**DEPARTMENT OF TRANSPORTATION
STATE OF GEORGIA**

FILE: NHS00-0002-00(861) Camden **OFFICE:** Engineering Services
P.I. No.: 0002861
SR 40 Widening and Reconstruction **DATE:** September 1, 2009

SUBJECT: IMPLEMENTATION OF VALUE ENGINEERING STUDY ALTERNATIVES

SUBJECT Value Engineering Study Responses

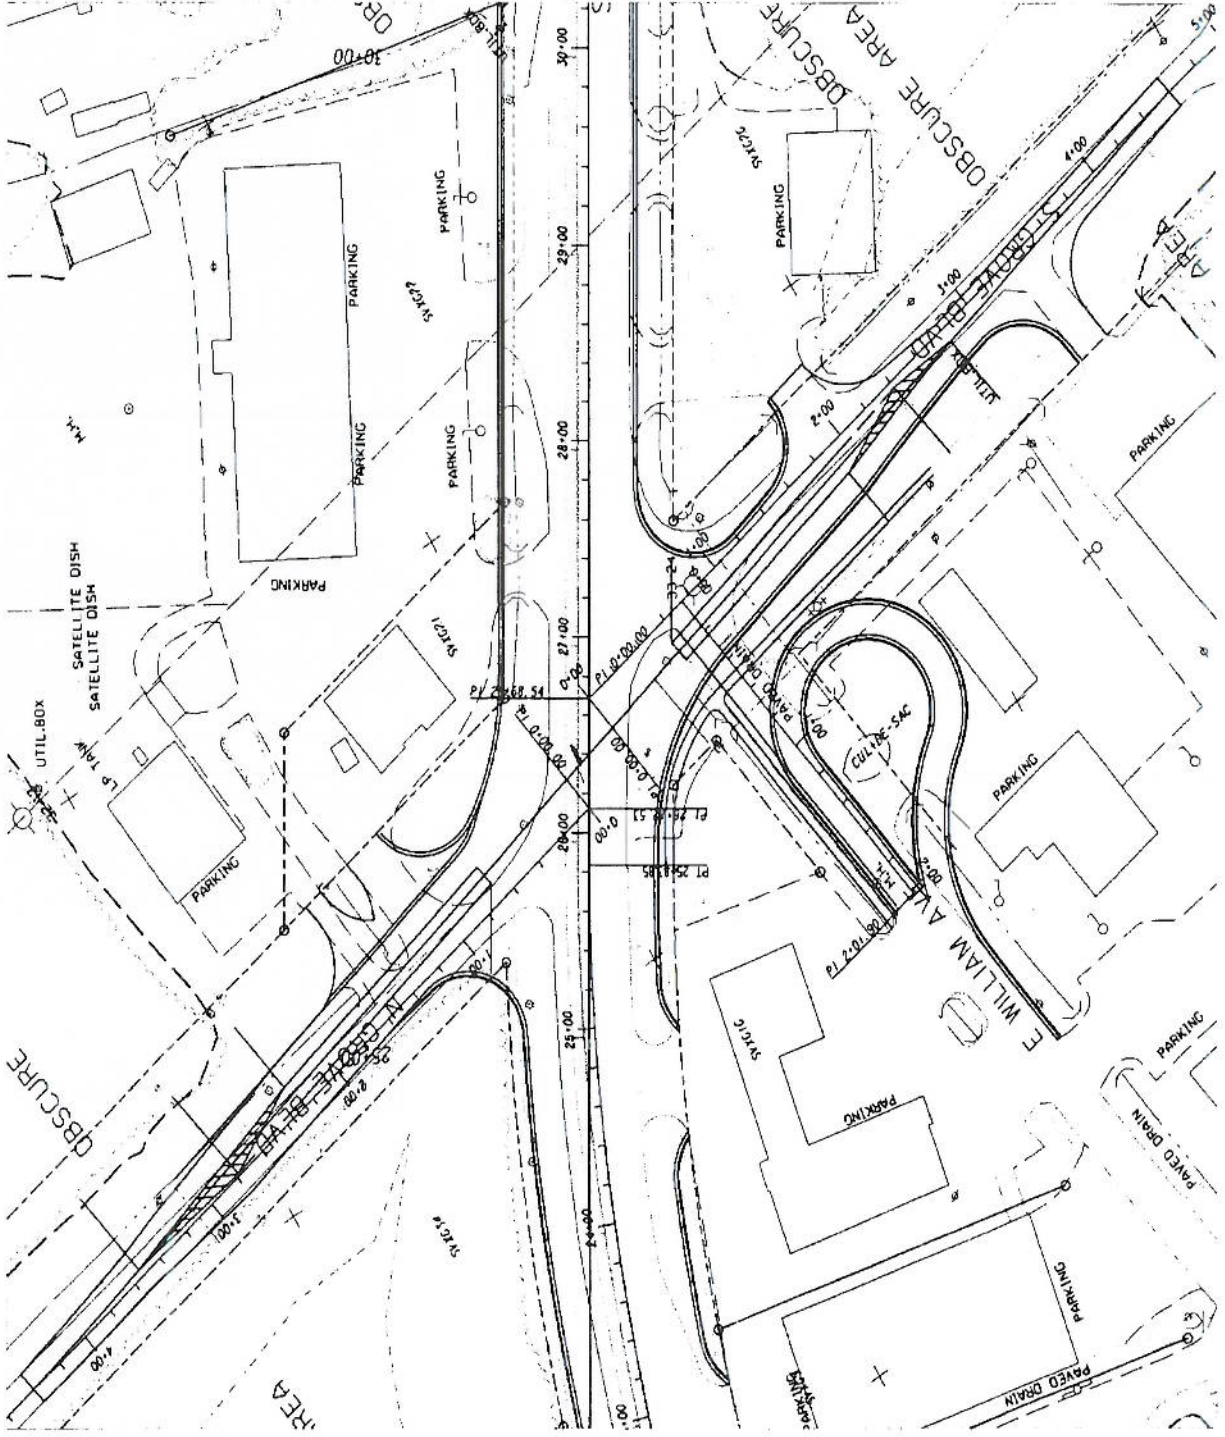
4. Idea I-3; Eliminate roadway widening on both sides of the existing road.

The current plans provide for widening and full depth pavement construction on both sides of the existing road to develop the required ultimate roadway width. Shifting the alignment to one side to eliminate the full depth construction on both sides will allow the construction staging and maintenance of traffic to operate at a safer and more efficient level. While Right of Way impacts should be similar from an affected area standpoint, the number of parcels should be reduced. The affected businesses appear to be far enough from the existing road to facilitate this shift however a final determination will need to be made.

➤ **VE Design Considerations is not accepted.**

The current alignment was shifted 6.5' to the left. Shifting the alignment anymore would impact businesses more on the left side. The reduction of lanes, shoulders and right of way should eliminate the need for right of way purchase on the right side like it was originally intended to do. This would reduce the number of parcels, construction and right of way costs. Plus, the addition of bike lanes would still require widening on both sides and should keep the proposed design within the right of way on the right.
